The Great Grid Upgrade

Norwich to Tilbury

2023 Non-Statutory Consultation Feedback Report

AENC-NG-CNS-REP-0007

Figure 4.18- South Norfolk section map

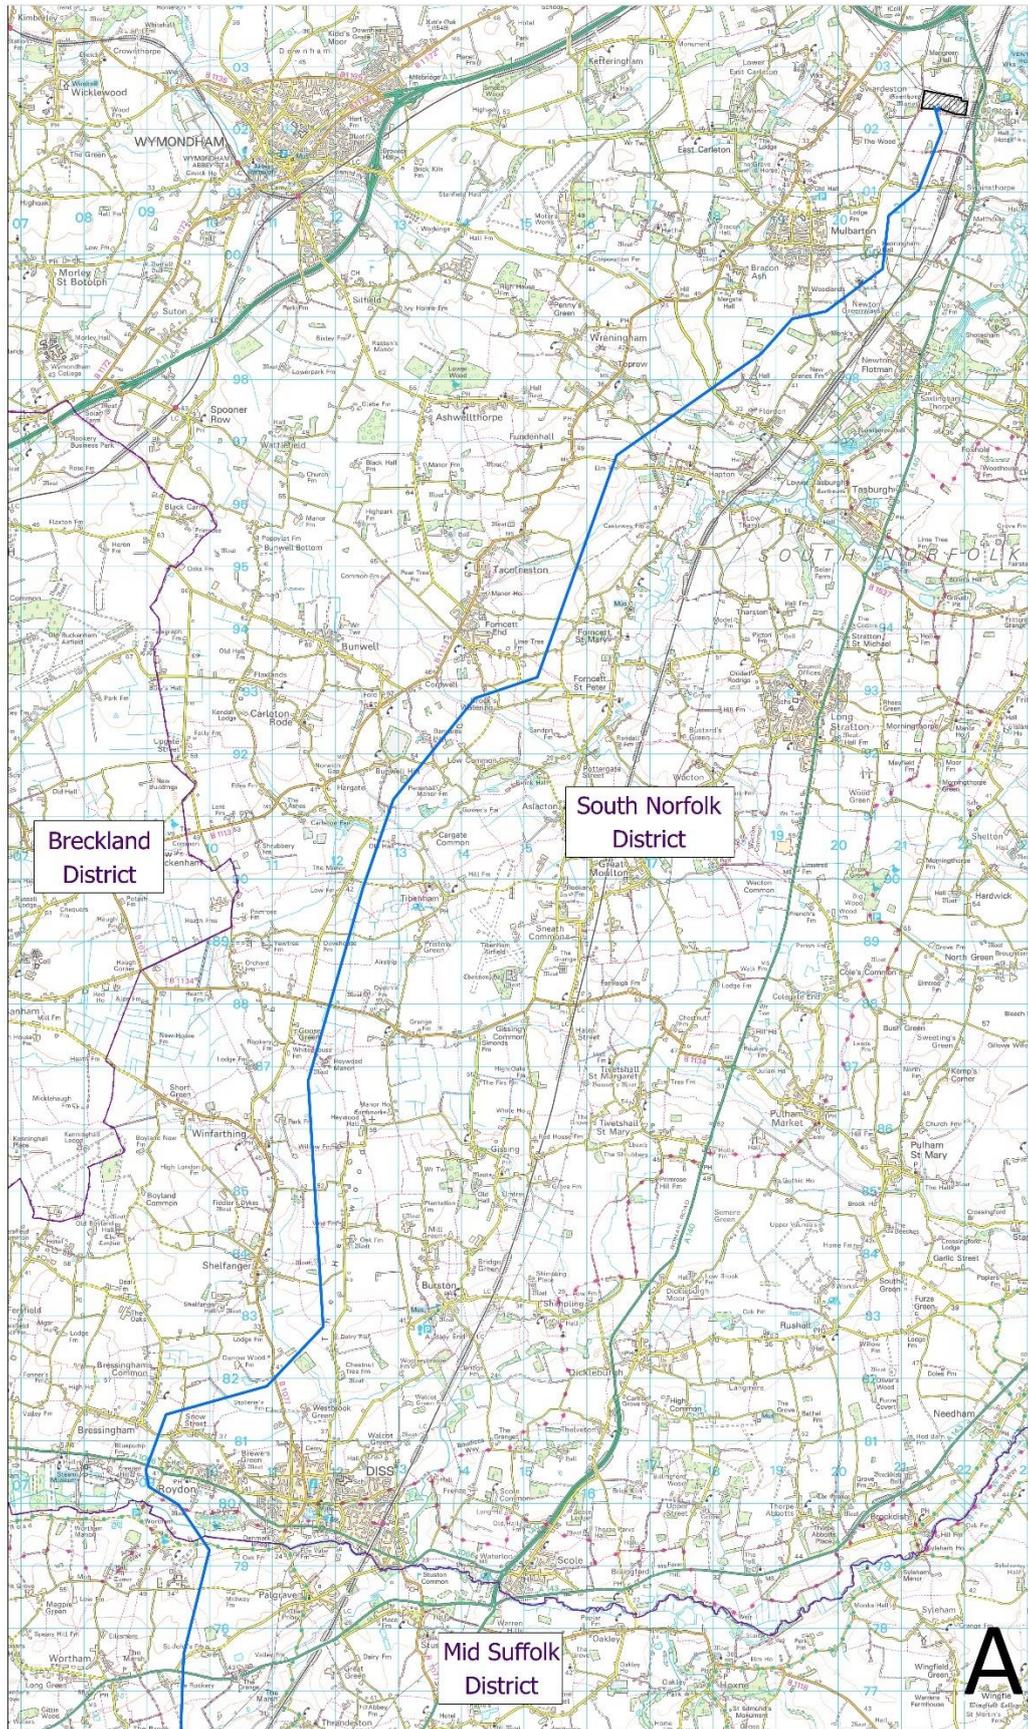
Ref no.	Summary of matters raised	National Grid's response
Agricultural Land		
4.11.1	Concern that the Project will take away valuable agricultural land / disrupt farming operations.	National Grid is and will continue to work with all landowners including farmers who may be affected by the proposals to understand the impacts on their operations and to work with them as the Project is developed. We will seek to work with the farming community to limit disruption where practicable. This includes providing prior warning of works which may result in the need to move livestock. Compensation claims for disturbance are considered on a case-by-case basis, if negative impact on farming operations can be proven. Particular agricultural matters can also be addressed through voluntary land agreements.

Figure 4.19- Mid Suffolk section map

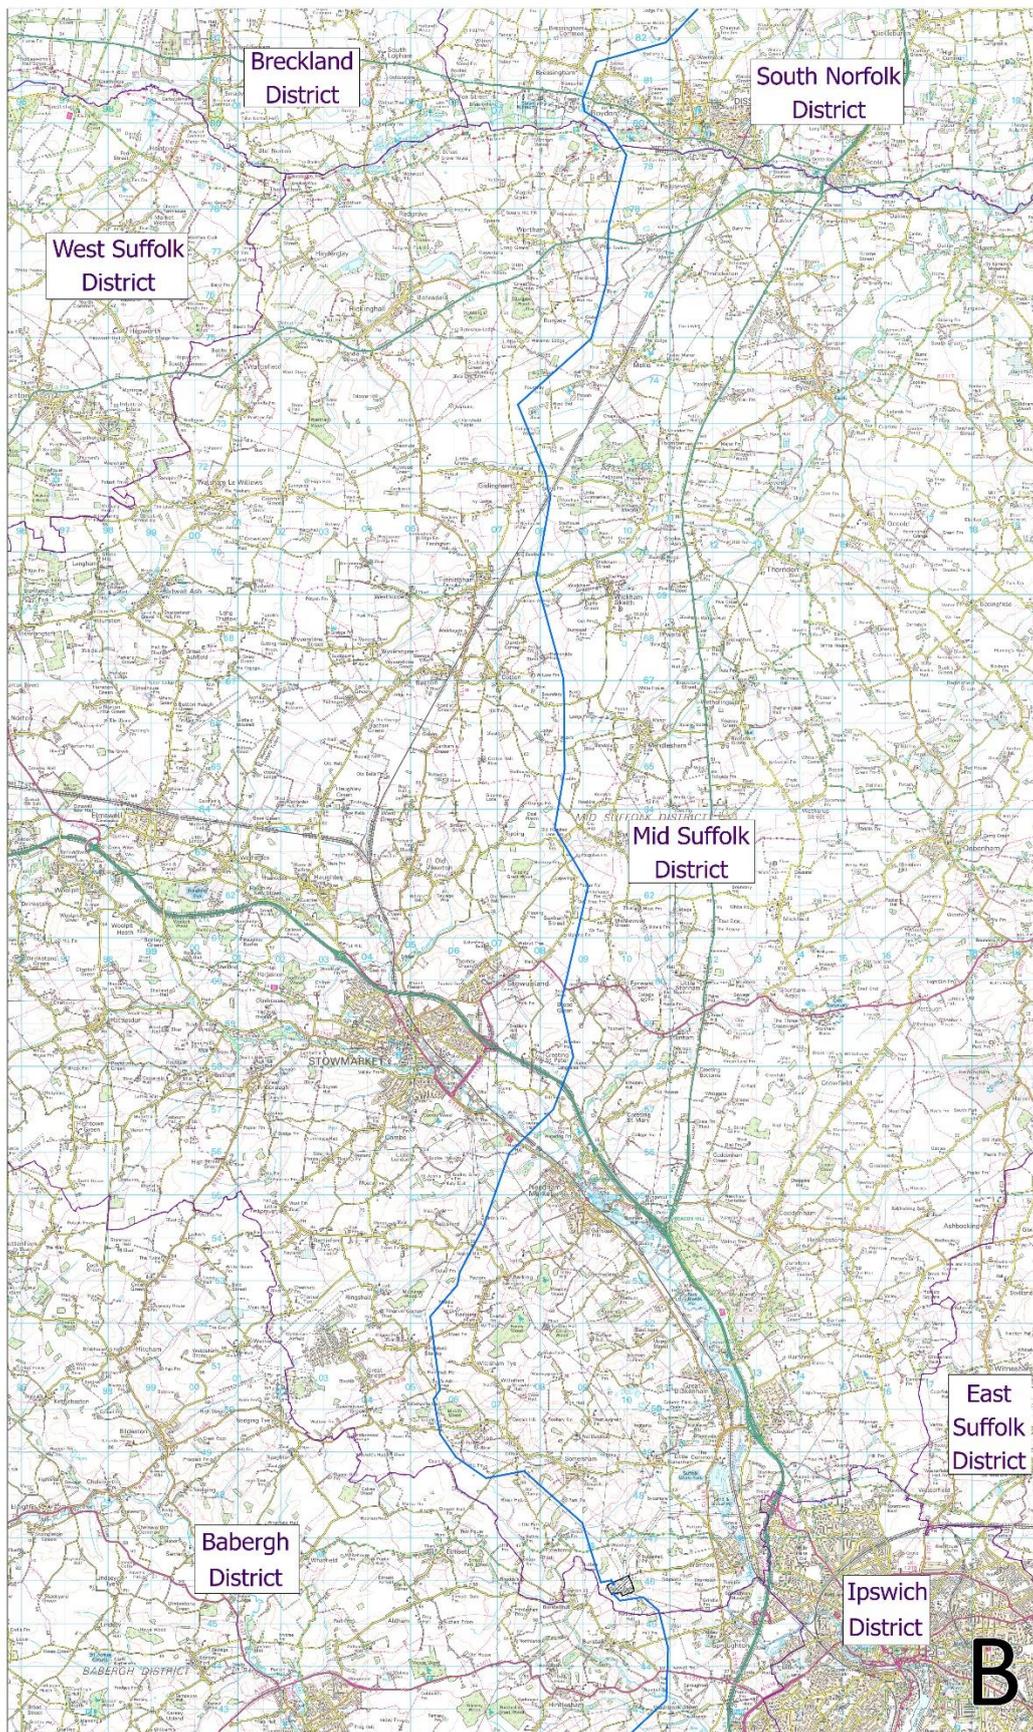
Ref no.	Summary of matters raised	National Grid's response
Agricultural Land		
4.12.1	Concern that the Project will take away valuable agricultural land / disrupt farming operations.	National Grid is and will continue to work with all landowners including farmers who may be affected by the proposals to understand the impacts on their operations and to work with them as the Project is developed. We will seek to work with the farming community to limit disruption where practicable. This includes providing prior warning of works which may result in the need to move livestock. Compensation claims for disturbance are considered on a case-by-case basis if negative impact on farming operations can be proven. Particular agricultural matters can also be addressed through voluntary land agreements.

Figure 4.20- Babergh, Tendring and Colchester section map

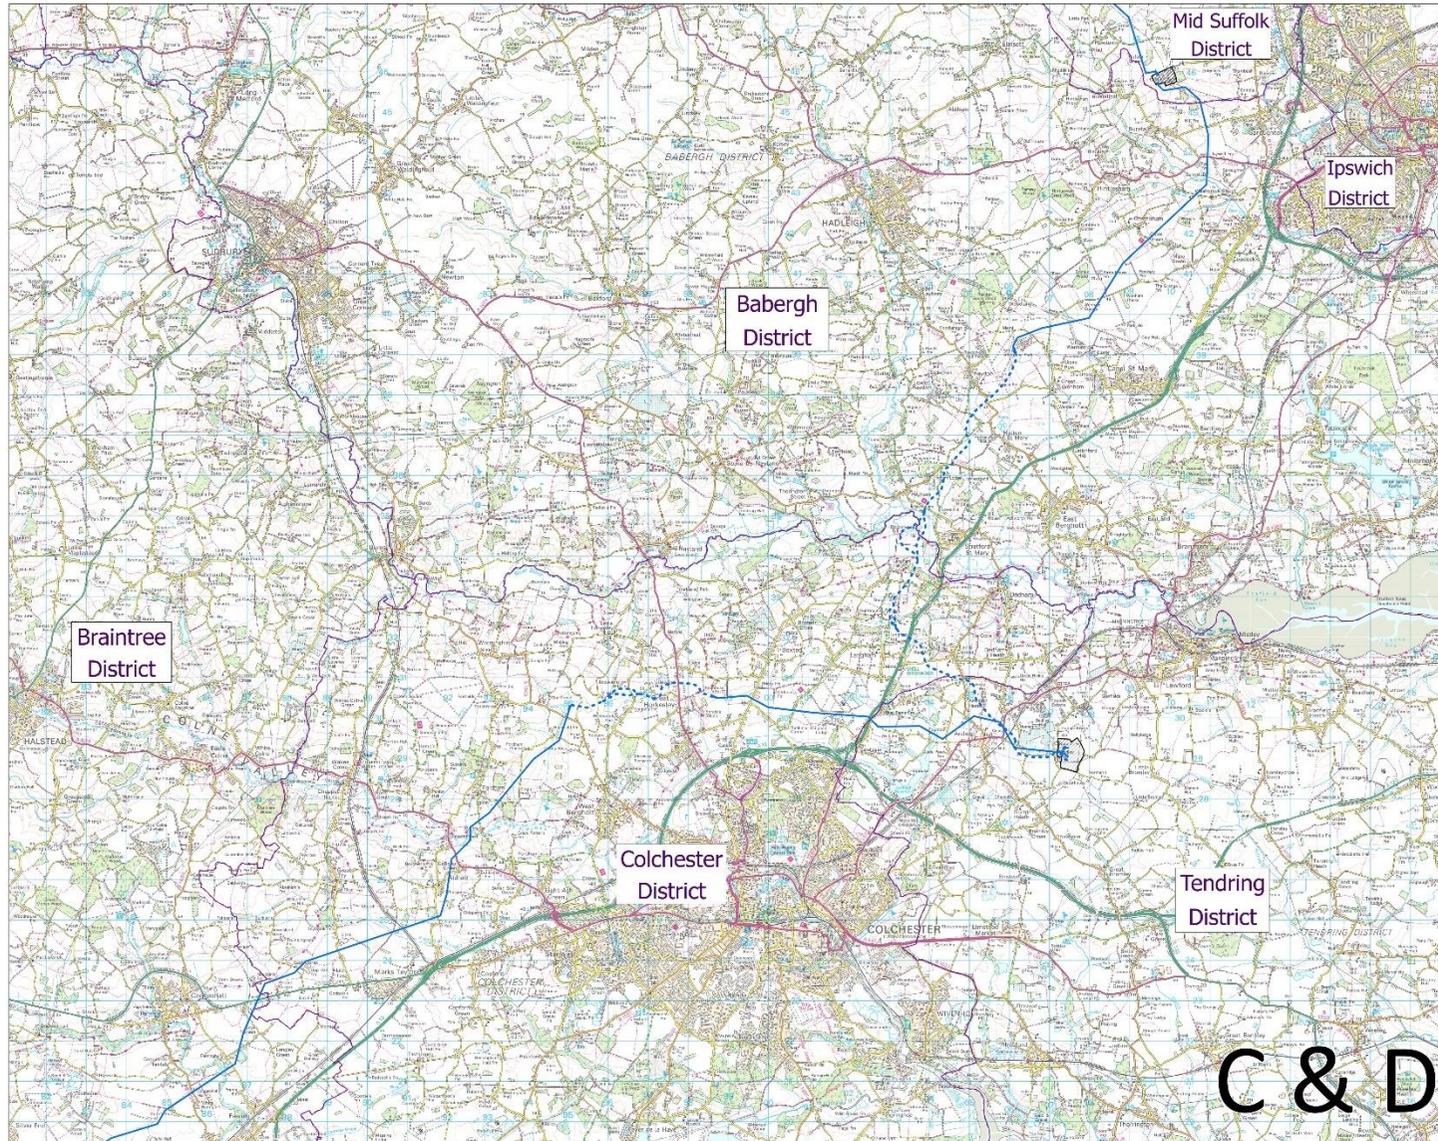
Ref no.	Summary of matters raised	National Grid's response
Agricultural Land		
4.13.1	Concern that the East Anglia Connection Node (EACN) substation will destroy productive farmland (i.e., contradictory to the UK ambition to grow more food, and pollution resulting in the need to transport food from abroad).	Siting of the East Anglia Connection Node (EACN) substation takes into account a wide range of factors and must arrive at a balanced position, in particular weighing the effects from the two overhead lines required to transmit the power from the site. National Grid will continue to work with all landowners, including farmers who may be affected by the proposals, to understand the impacts on their operations and to work with them as the Project develops. We will seek to work with the farming community to limit disruption where practicable. Where land is required for new permanent apparatus, we will look to acquire the minimum area required.

Figure 4.22- Chelmsford section map

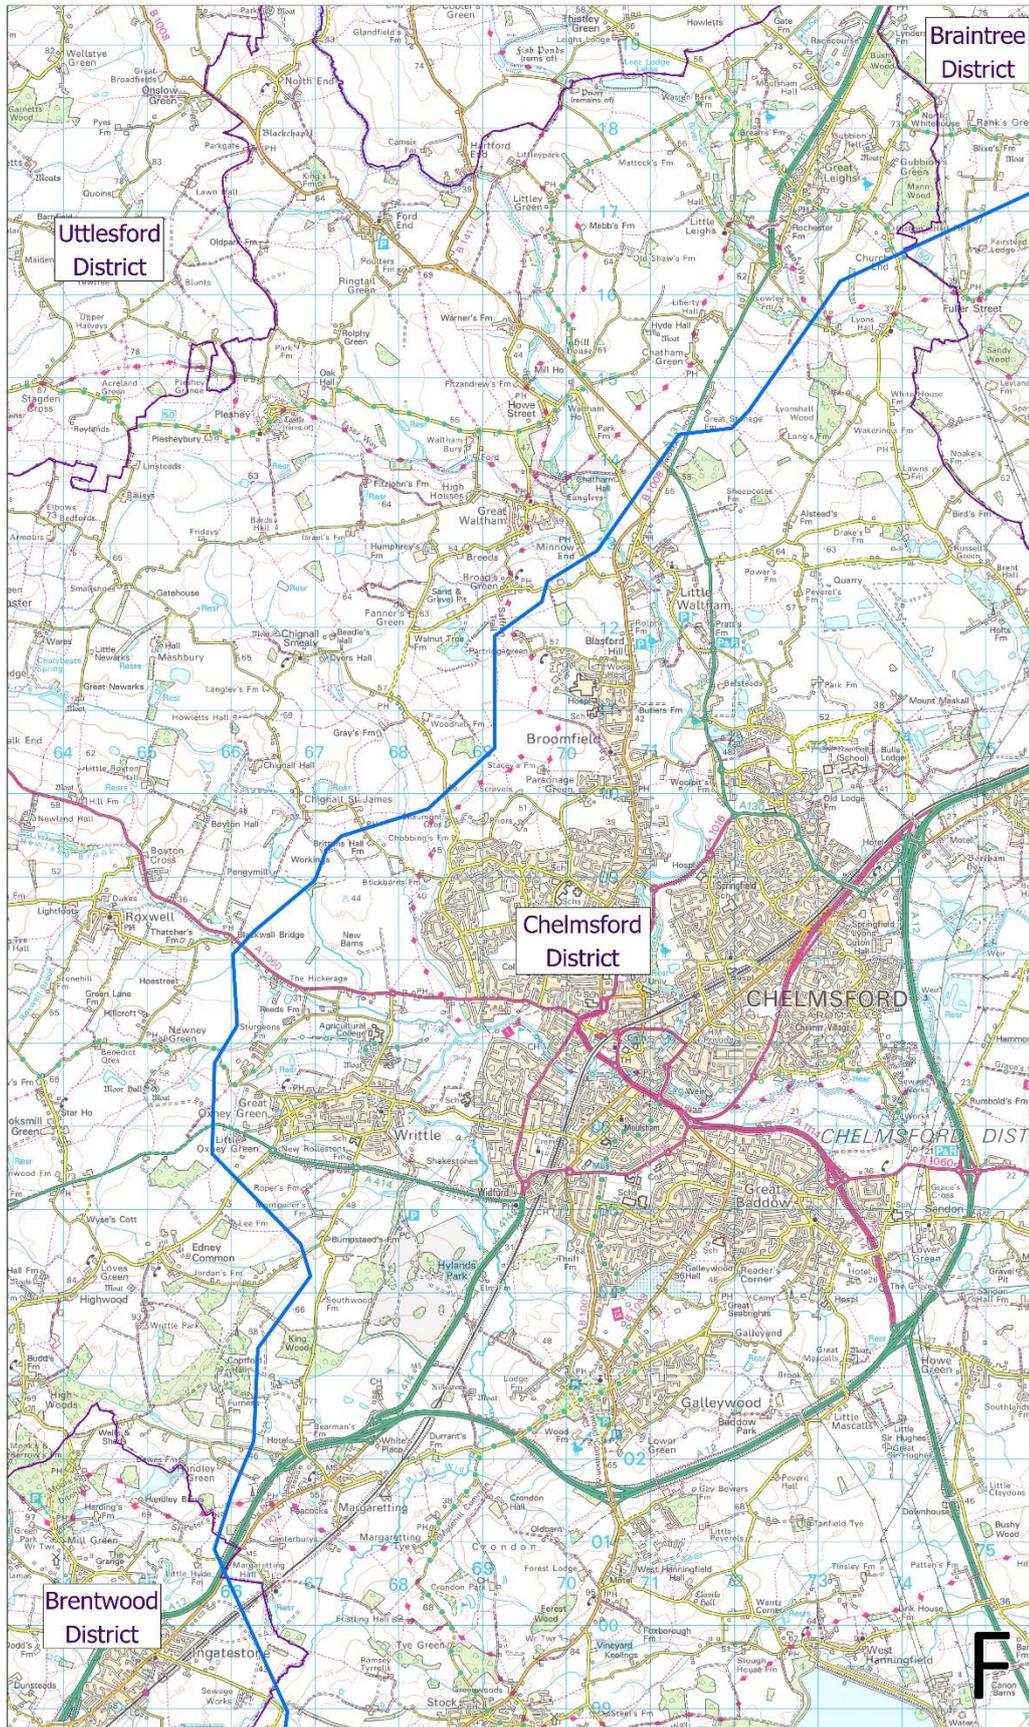
Ref no.	Summary of matters raised	National Grid's response
Agricultural Land		
4.15.1	Concern about the impact of concrete haul roads on farming (e.g., concern over the loss of farming/ grazing land due to setting of concrete haul roads (for up to 3 years) around pylon sites / Concern on the long term impacts of concrete haul roads on soil structure and drainage in farming fields (fields that are tile drained)).	National Grid is currently in the process of determining where haul roads and work areas will be required, including determining the methodology on how these will be installed, materials used and the duration they will remain in place. There may be temporary impacts on agricultural drainage systems, and this will need to be mitigated through installing temporary drainage systems and reinstatement of existing drainage on the completion of the works. Soil management will be in place when stripping and storing soil to ensure that reinstatement can be successful and restore the land to its original condition.

Figure 4.23- Basildon and Brentwood (and Chelmsford east of Ingatestone) section map

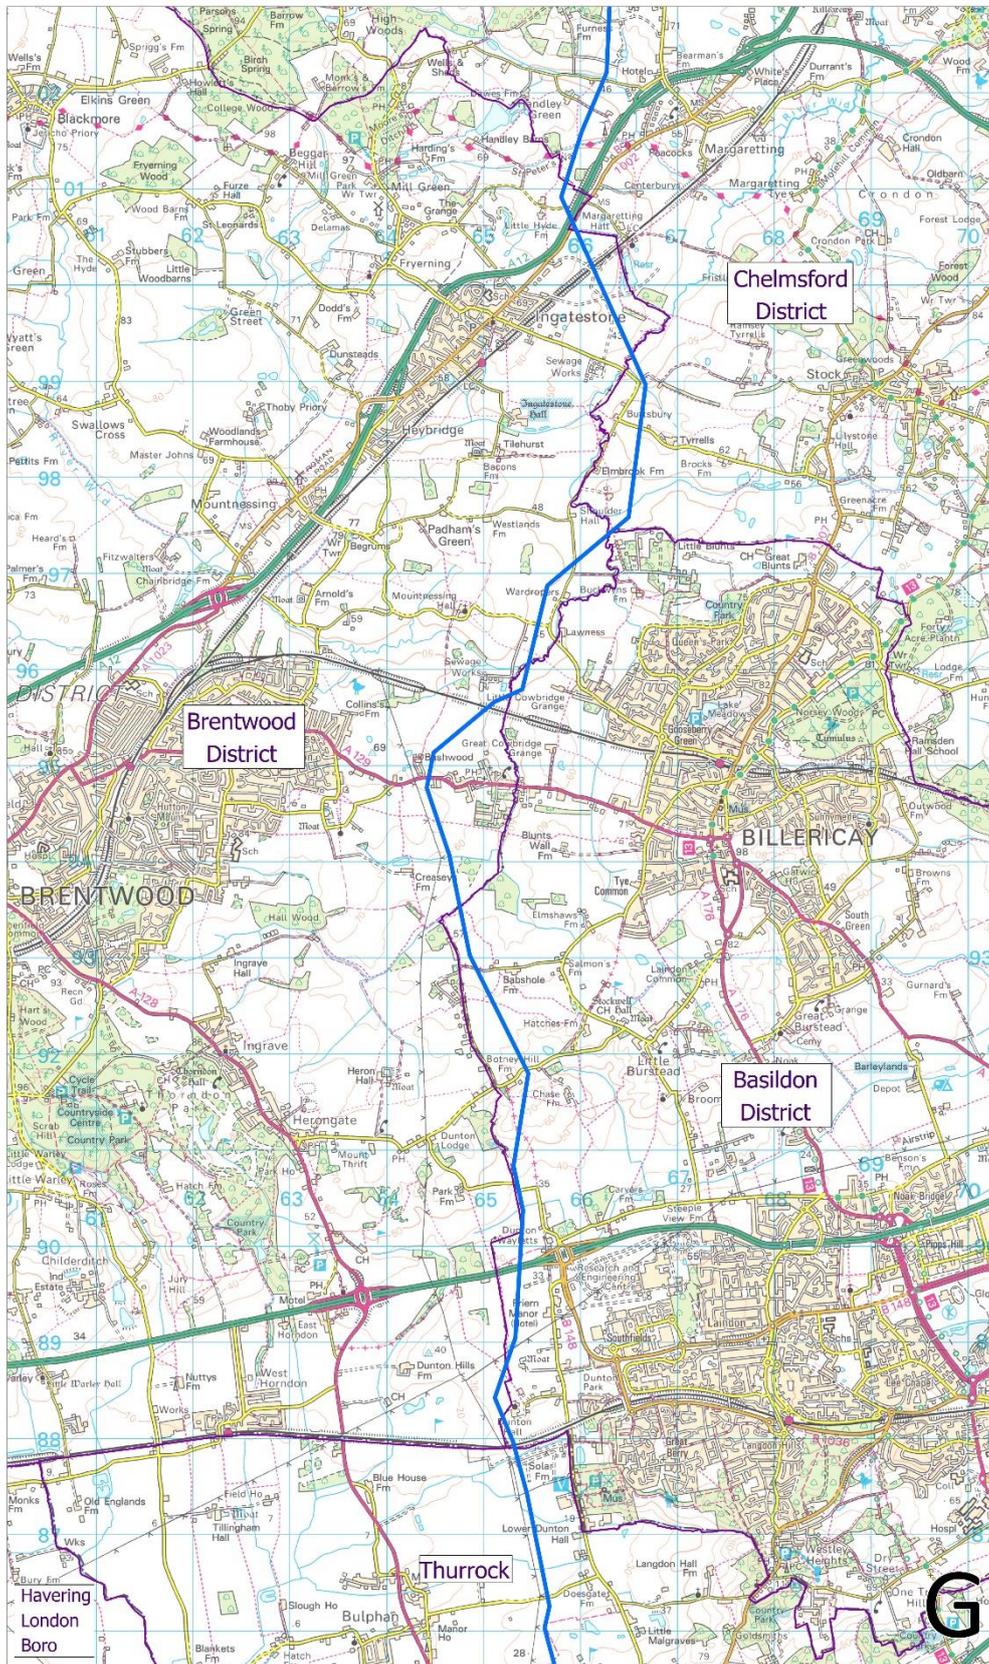
Ref no.	Summary of matters raised	National Grid’s response
Agricultural Land		
4.16.1	Concern that the Project will impact agricultural electric fencing due to electromagnetic fields, and request that National Grid fund any permanent non-electric fencing required as a result.	<p>The management and control of microshocks in the UK is set out in a Code of Practice produced by Government. This Code of Practice recognises that control of microshocks is not based on a simple quantitative limit. Rather, there is a suite of measures that may be called upon in particular situations.</p> <p>The Code of Practice provides a complete system for the control of microshocks, specifying what action is required to be taken, by whom, and under what circumstances. The Project has been designed in accordance with this Code of Practice which is incorporated in the National Grid policies and guidance. At the point that any proposed overhead line is operational, any residual microshocks that were reported would fall under the provisions of this Code of Practice and National Grid would mitigate in line with this guidance. This includes any impacts to agricultural electric fencing.</p>
